Van's RV-10 Service Bulletin

RAA

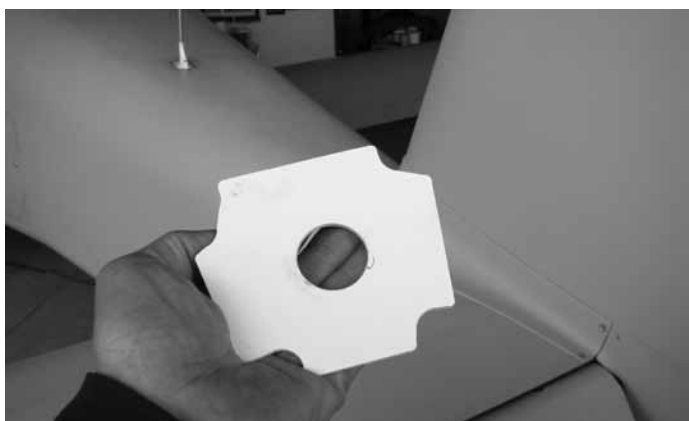
The procedure is to take the load off the nosegear by tying the tail down so that the shock absorber unit may be removed. A careful inspection of the socket of the engine mount is to be carried out, and for this the powder coat paint may have to be removed either by abrasion or by the use of a chemical paint stripper. In some cases there will be cracks emanating from the centre hole that accepts the top end of the shock absorber unit. To date this has happened only to aircraft that have had rough field operations.

If there are no cracks the procedure is to slip the Vans-supplied doubler plate over the top of the shock absorber unit and reinstall everything. The plate is thick enough to spread the bump loads to the edges of the socket in the engine mount.

There is a second check to be done at this point. With the shock installed the owner must check for vertical play that can occur as a result of wear on the elastomeric donuts of the shock assembly. If more than 3 washers are required to remove the play the donuts must be replaced with new. The whole procedure should take only half a day.

If there are cracks the engine and mount must be removed to have Vans-supplied reinforcement pieces welded in place to reinforce the socket. For most owners this will mean that the mount must be removed from the engine to be sent out for "precision welding".

Although Vans does not specify the method it would be foolish to use a wire feed welder, either with or without argon gas. Vans specifies that ER70 S-2 filler rod must be used. This is the rod commonly used when TIG or oxyacetylene welding, and every welding supply will stock it.
